FURTHER STATEMENT FROM ST LEONARDS & ST IVES PARISH COUNCIL ID: 814793

Bournemouth Dorset and Poole Waste Plan Hearing 26th- 28th June 2018 Reference: Woolsbridge Industrial Estate - Points 21 -23 & 88-91 & 109; 110

APPENDIX 1

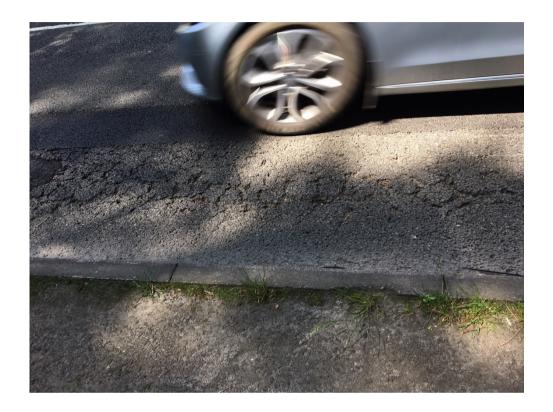
- 3.7. We have not seen any air quality tests and impact reports on housing lining the Horton Road route. The number of lorry's with high axle weights have already collapsed the road (into a left handed rut cause by the road camber) and drains along the Horton Road route. See Appendix 1

Common and repeated damage up and down the Horton Road, note the car axle width. It is predominately lorry's doing this damage.
